UNITED STATES
DEPARTMENT OF THE INTERIOR
BUREAU OF LAND MANAGEMENT

SUNDRY NOTICES AND REPORTS ON WELLS
*Do not use this form for proposals to drill or re enter an
abandoned well. Use Form 3160-3 (APD) for such proposals.*

Saguaro AGS Federal Com #5

Yates Petroleum Corporation plans to plug and abandon this well as follows:

WELL NAME: Saguaro AGS Federal #5 FIELD: Dagger Draw

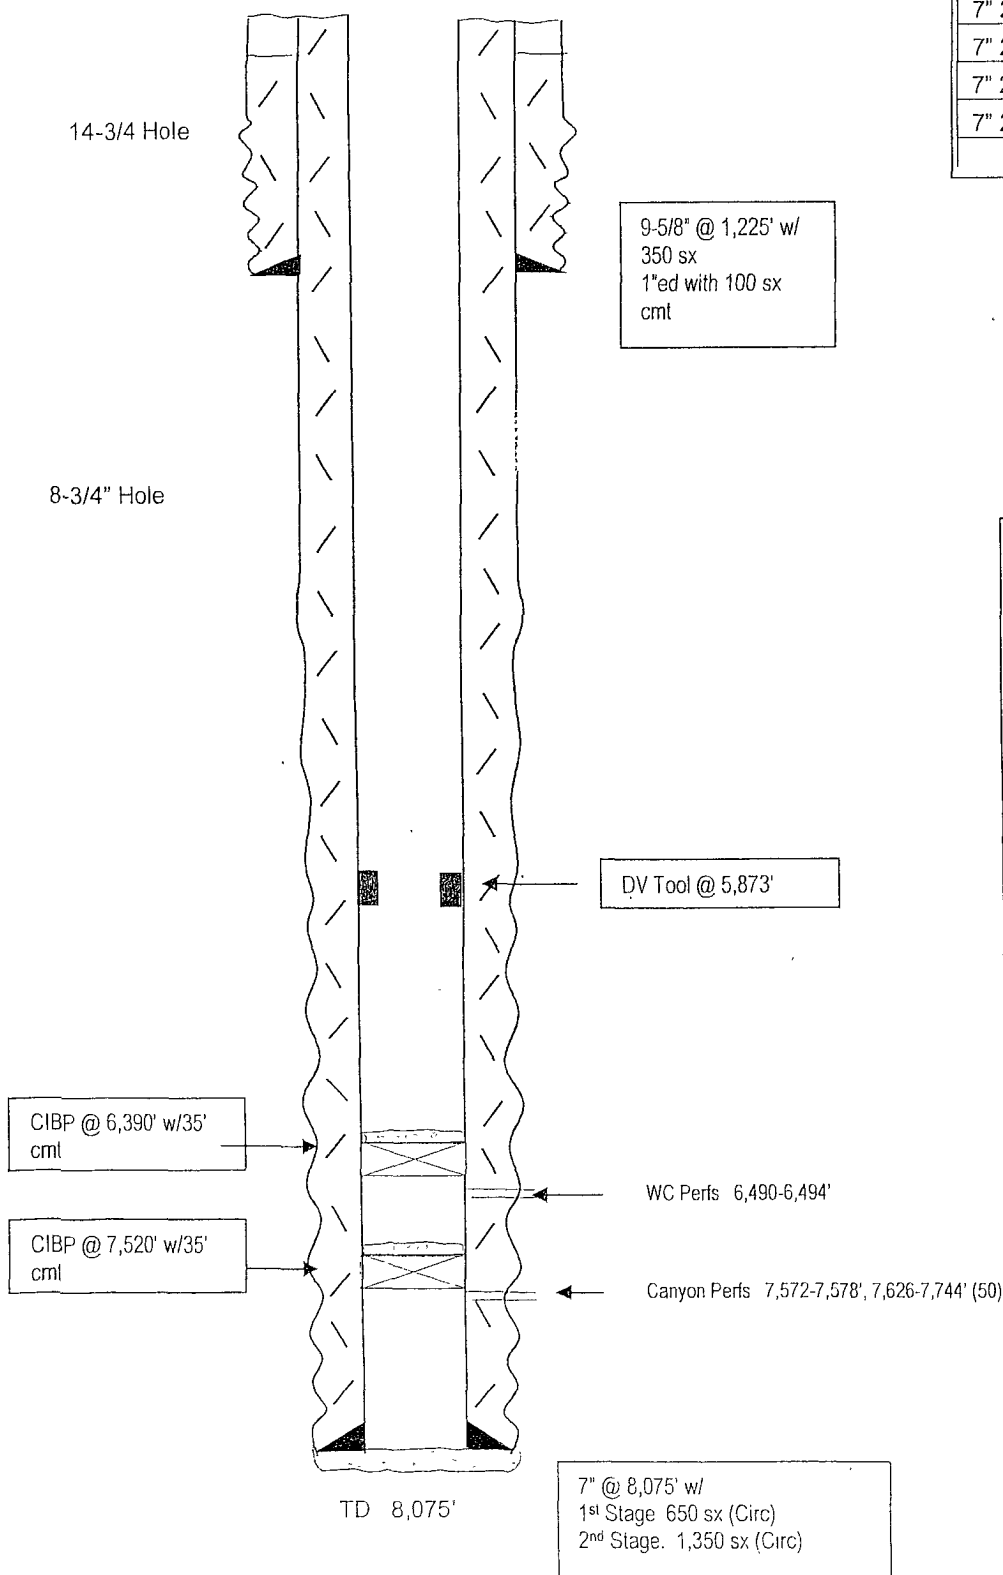
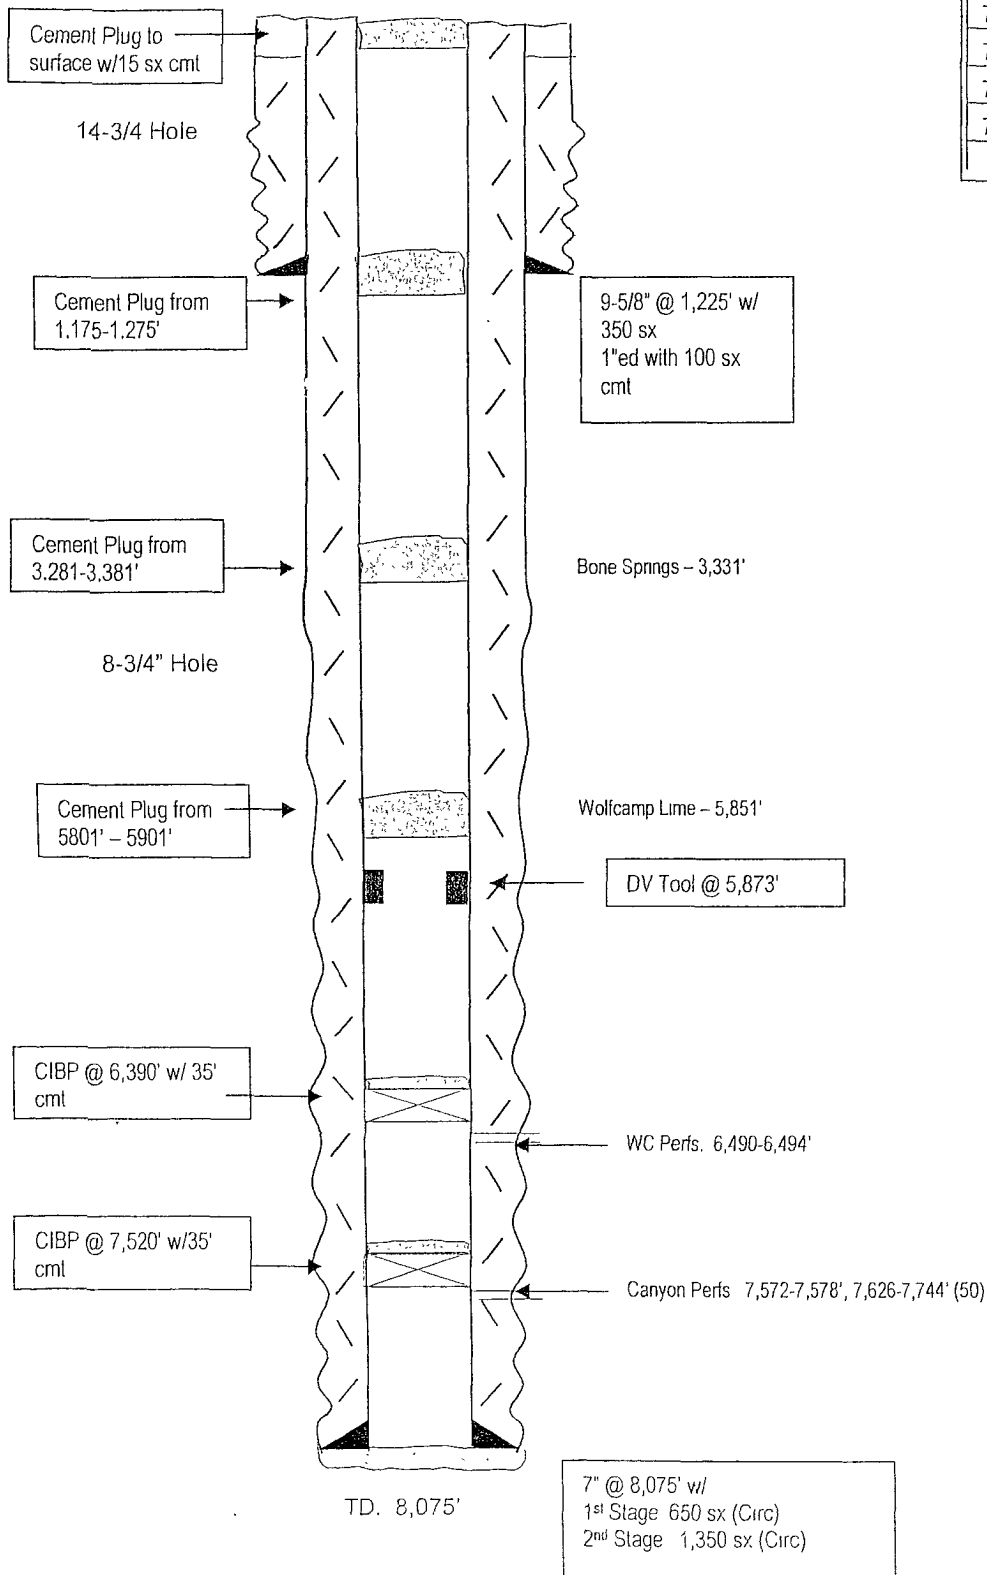
NOTE: CIBP's at 6390' + 35' cement and 7520' + 35' cement

1. Rig up safety equipment as needed.
2. Spot 100' cement plug (25 sx) from 5801'-5901'.
3. Spot 100' cement plug (25 sx) from 3281'-3381'.
4. Spot 100' cement plug (25 sx) from 1175'-1275'. Tag plug.
5. Spot 100' cement plug (25 sx) from 100' to surface. Tag plug.
6. Cut off wellhead and install dry hole marker.

X Plugs should be 100 ft. plus 10% per 1,000 Ft. add 10%

Gerry Guye, Deputy Field Inspector
NMOCD-District II ARTESIA
Gerry Guye, Deputy Field Inspector
NMOCD-District II ARTESIA
**SEE ATTACHED FOR
CONDITIONS OF APPROVAL**
